REV.
C

SAE AS3243

(R) BOLT, MACHINE – DOUBLE HEXAGON EXTENDED WASHER HEAD, PD SHANK, NICKEL ALLOY, UNS N07718, 185 KSI UTS MIN, .1900-32 UNJF-3A

FIGURE 1 - BOLT

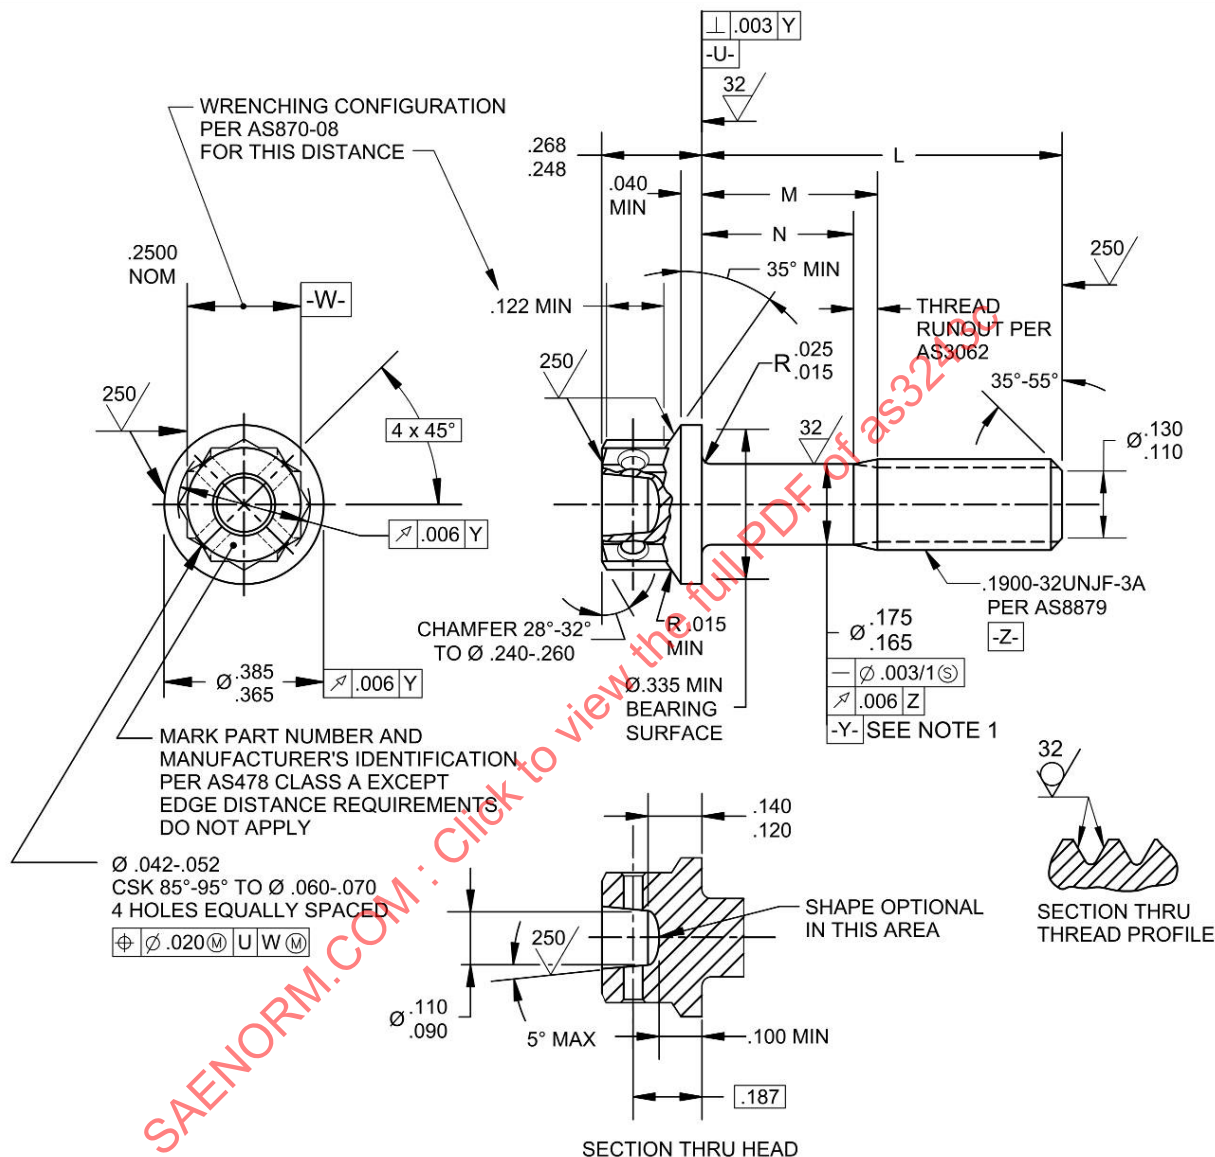
REVISE WRENCHING ELEMENT RUNOUT CALLOUT (RELOCATE FROM WRENCH FLATS TO POINTS). REVISE THREAD SPECIFICATION TO AS8879. REVISE LIGHTENING HOLE CONFIGURATION (ADD SECTION VIEW) TO ALLOW OPTIONAL SHAPE AT BOTTOM OF HOLE, ADD SYMBOL FOR MMC TO POSITION TOLERANCE FOR SAFETY WIRE HOLES, AND FIGURE 1 REDRAWN.
